Subject: **BSPP RESPONSE TO ALUC COMMENTS OF MARCH 22, 2010 ON ALUC APPLICATION AND SUBSEQUENT CORRESPONDENCE BY EMAIL ON APRIL 13, 2010**
BSPP RESPONSE TO ALUC COMMISSION COMMENTS FROM MAY 13, 2010 COMMISSION MEETING
DOCKET NO. (09-AFC-6)

**BLYTHE SOLAR POWER PROJECT (09-AFC-6)
RESPONSE TO ALUC COMMENTS OF MARCH 22, 2010
ON ALUC APPLICATION AND SUBSEQUENT CORRESPONDENCE
BY EMAIL ON APRIL 13, 2010**

Response Date: May 4, 2010

Figure 10. Location of the Victorville 2 Project Site with respect to the Southern California Logistics Airport

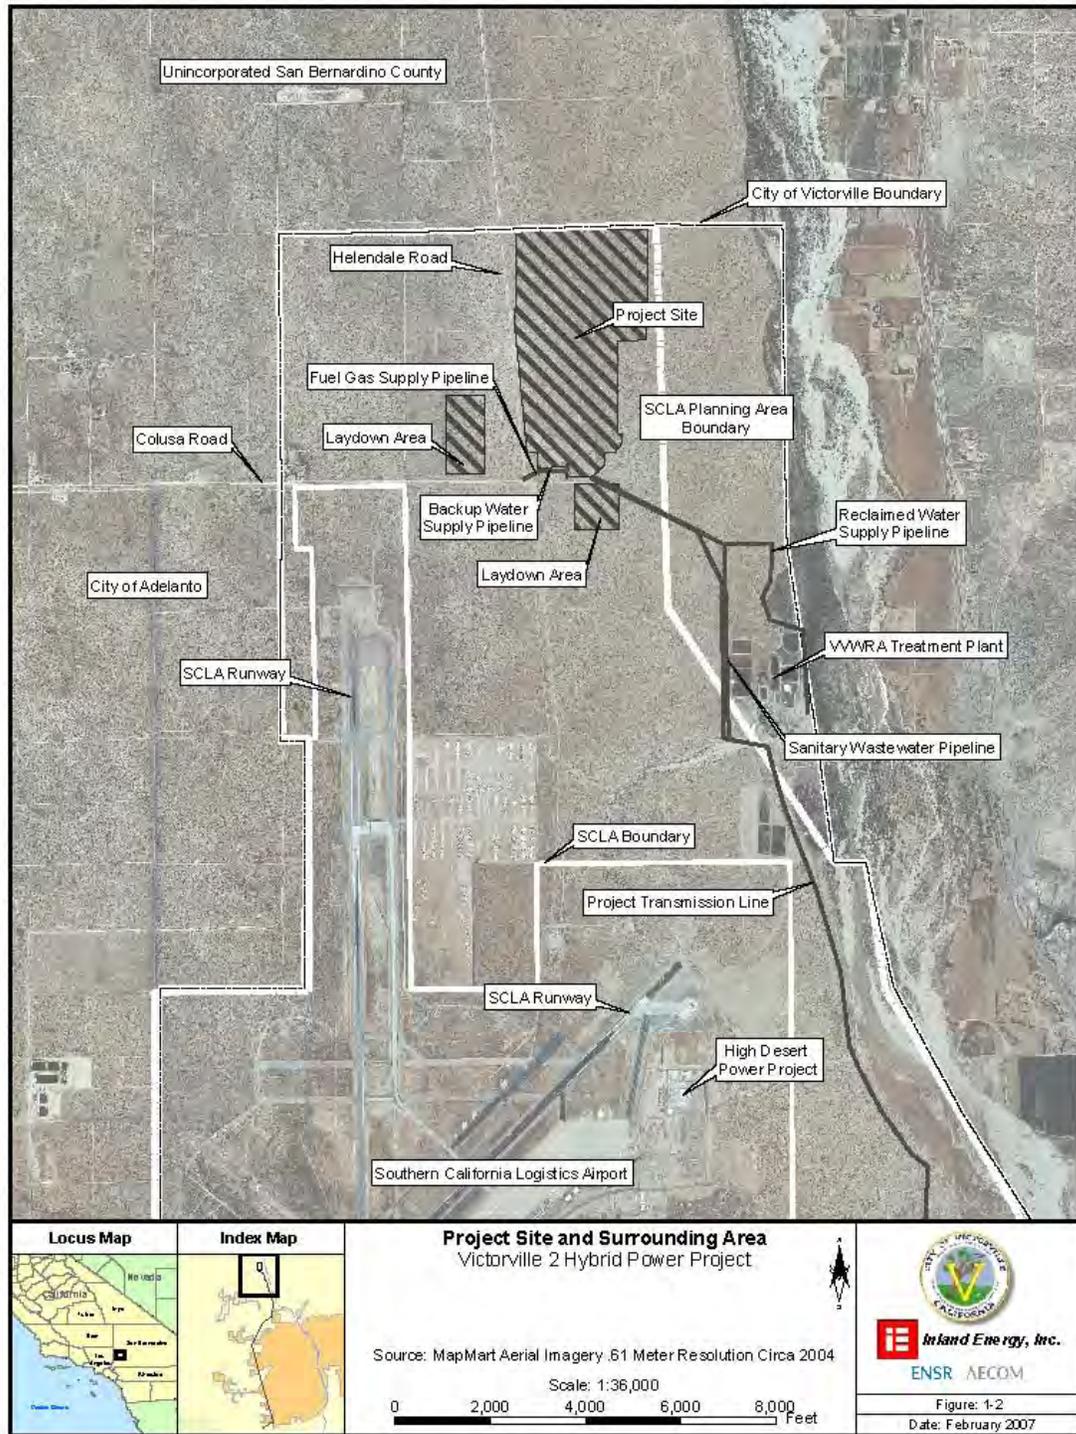
Detail how BSPP is comparable to the Victorville (VV2) project (i.e. total project acres, total MW, location related to distance from airport and to flight paths, orientation of panels)

The Victorville II Project (VV2) is very similar in design to the PHPP and is located immediately adjacent to the north and east of the departure end of Runway 35 at the Southern California Logistic Airport (SCLA). The VV2 plant site shares a boundary with the SCLA. The VV2 plant is proposed for a 275 acre site and is composed of two natural gas fired combustion turbine generators (CTGs), two heat recovery steam generators (HRSGs), and one steam turbine generator (STG), and a 250 acre solar thermal mirror array with parabolic trough mirrors. The power rating of the solar thermal mirror array is a nominal 50 MW. The overall power rating of the VV2 project is 570 MW. Figure 10 presents a map showing the location of the VV2 project and the SCLA. At a nominal 1,000 MW, the BSPP is considerably larger than the solar field for VV2, but it is farther away from the Blythe Airport and its traffic patterns (approximately 8,200 ft from Runway 35) compared to the distance from the VV2 project to the SCLA runways and traffic patterns (approximately 5,000 ft from the departure end of Runway 35).

Figure 11. Power Block 4, Airport Compatibility Zone, and Wind Rose for Blythe Airport

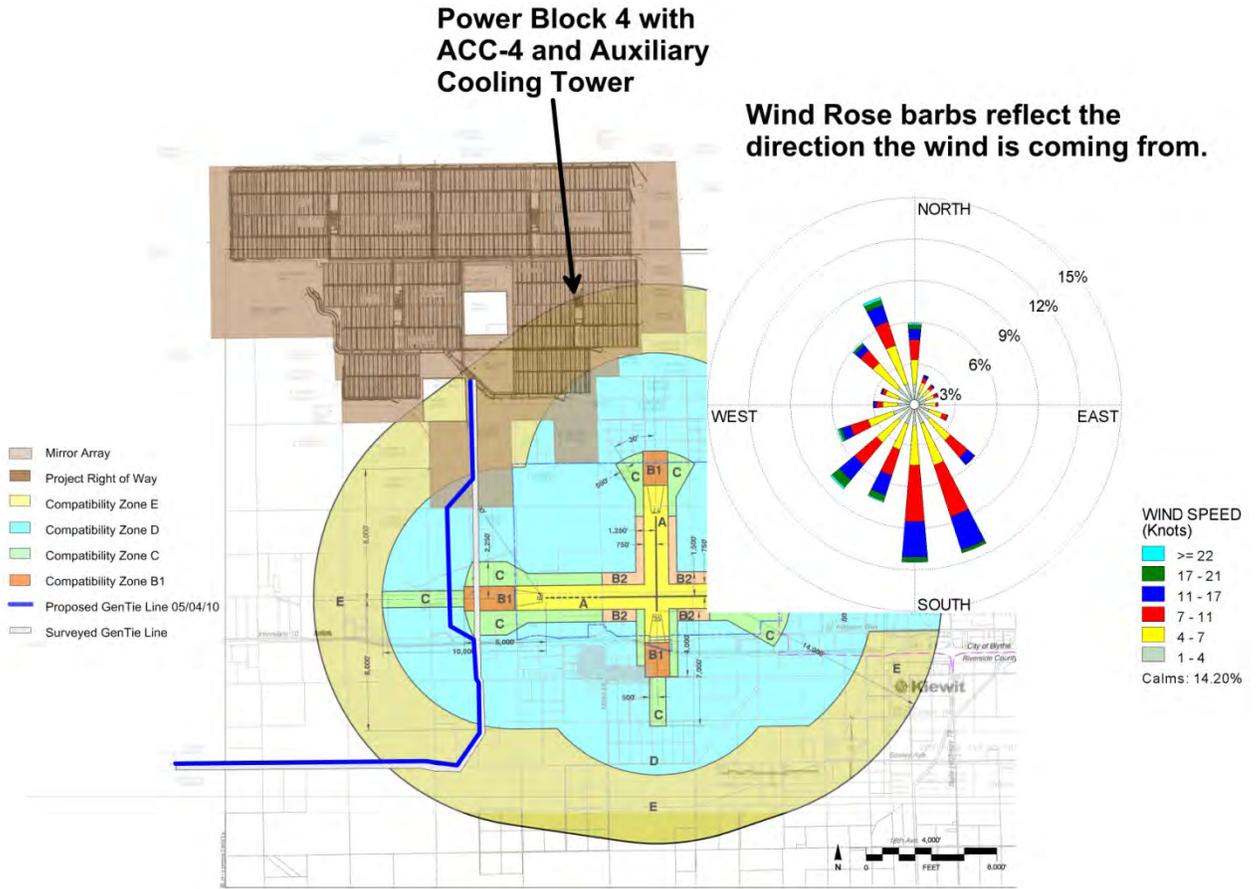
Based on what data is the CEC “not concerned with [the small auxiliary two-cell wet cooling towers] being a potential hazard to aviation? Is any data available for these similar to the dry cooling towers on temperature rise and upward velocity? How often, how long, and what time of day are these to be used?

There is a potential for the plume from the ACC-4 to drift into the Airport Compatibility Zone. Figure 11 presents the location of the Project, the compatibility zone, and a wind rose. A wind rose is a meteorological diagram that graphically displays the frequency of occurrence of the distribution of wind speed and wind direction at a measurement location. In the wind rose, the individual barbs represent the wind blowing from a given direction, with the length proportional to the frequency of wind flow from that direction. For example, in Figure 11, the wind barb at the top of the figure represents the frequency of time the wind blows from the north to the south. Since the length of the wind barb extends to the 6% circle, the frequency of winds blowing from the north at the Blythe Airport is 6%. Encoded on the wind barb by color are the relative frequencies of winds of various speeds for that given direction.

Approximately 20% of the time, the wind as measured at the Blythe airport (2002-2004) could cause any plume from ACC-4 to advect to the south and southeast over the AIA. For the remaining approximately 80% of the time, the ACC plume will either rise vertically due to calm winds or will advect in a general northward direction away from the AIA. Please note that the blue, red, and green colors on the wind rose in Figure 11 represent occurrences of wind speeds 7 knots and greater. At these speeds, wind shear across any ACC plume will tend to rapidly dissipate the plume and will reduce or eliminate any potential for turbulence in the plume to affect aircraft operations. Consequently, the frequency of occurrence of ACC plumes that could advect into the AIA and potentially pose a hazard to aviation is well less than 20%. The most problematic time for potential turbulence from the ACCS will be during periods of calm winds, which generally occur at night and in the early morning hours.

Figure 12. Mirror Array Disturbed Area in Compatibility Zone D and Total Project Area in Zone D

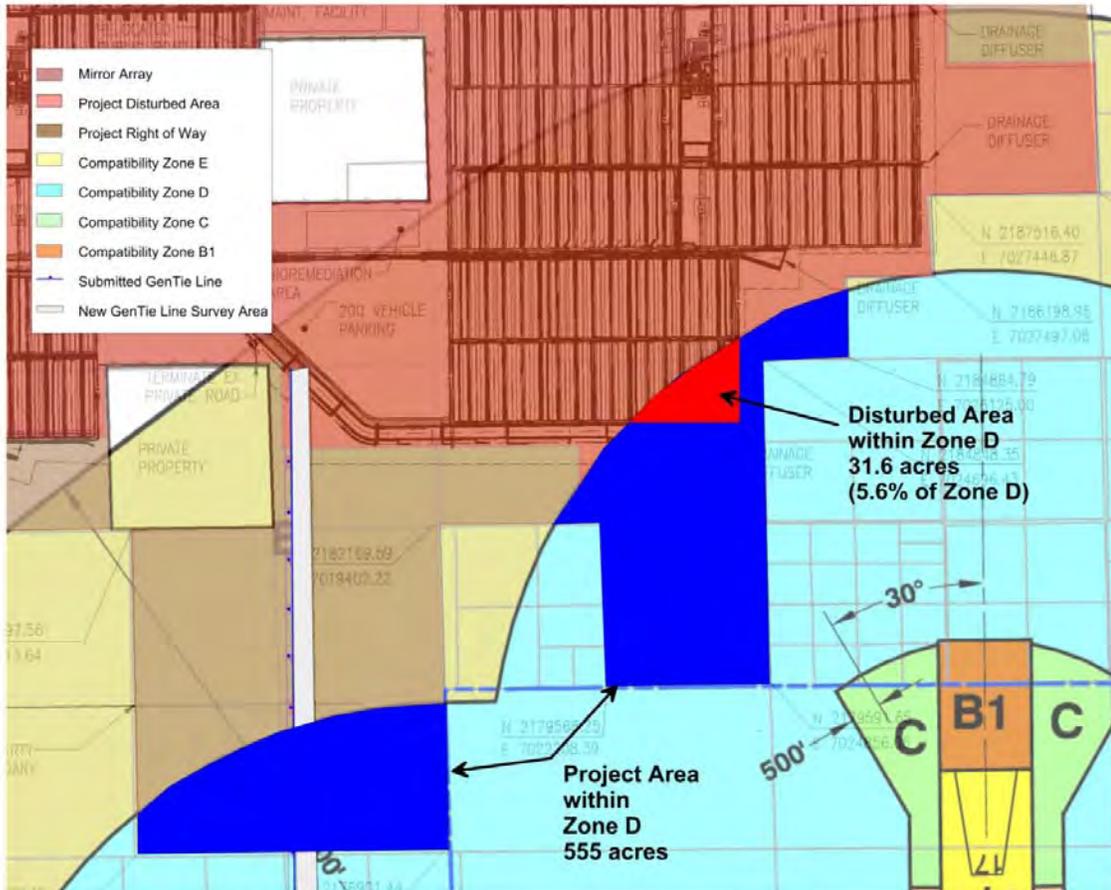
Clarify the project footprint area and area left as open space (free of most structures and other major obstacles such as walls, large trees or poles greater than 4 inches in diameter measured 4 feet above the ground, and overhead wires) for the project area located within Zone D.

Figure 12 presents a map showing the Airport Influence Area for Blythe Airport and the Right of Way and Area of Disturbance for the BSPP. Approximately 555 acres of the BSPP project area are located within Compatibility Zone D. Within Zone D, mirrors will be located on approximately 31.6 acres, or 5.6% of the total project area within Zone D. In addition to the small 31.6 acre footprint of the mirror arrays in Zone D, there will be small footprints for approximately three power poles.
